AMENDMENTS TO THE DRAWINGS

REMARKS

Applicant has carefully studied the outstanding Official Action mailed on April 11, 2007. This response is intended to be fully responsive to all points of rejection raised by the Examiner and is believed to place the application in condition for allowance. Favorable reconsideration and allowance of the application are respectfully requested.

FIG. 6

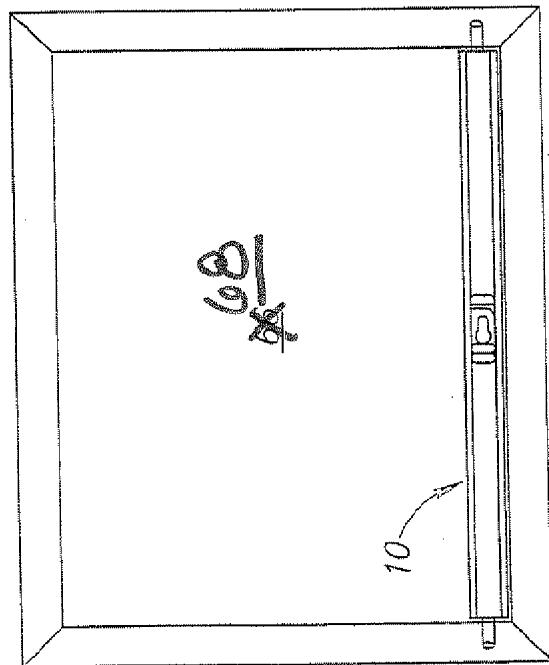
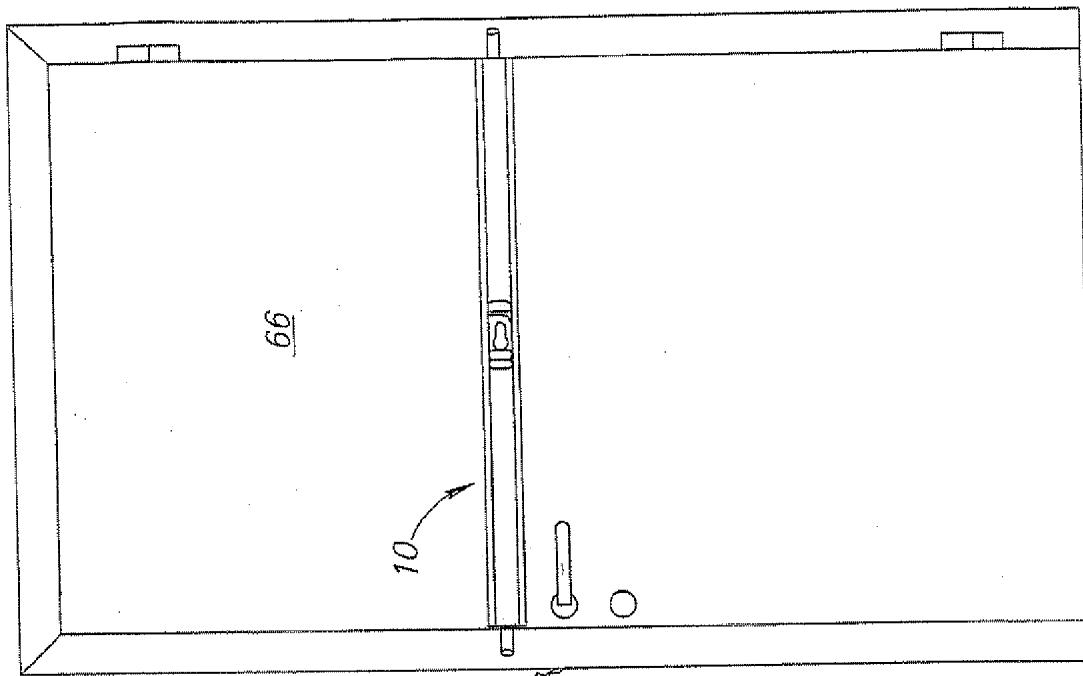
Fig. 6 of the drawings stands objected because reference character 66 on the window should be 68. The drawing has been accordingly corrected to overcome this objection.

Please substitute the attached complete set of drawing sheets for the previously presented drawing sheets. The attached sheets of drawings includes an amended Figure 6 in which reference numeral 66 (left hand side) has been changed to 68, as suggested in the Action. An annotated Figure 6 showing the amendment is attached.
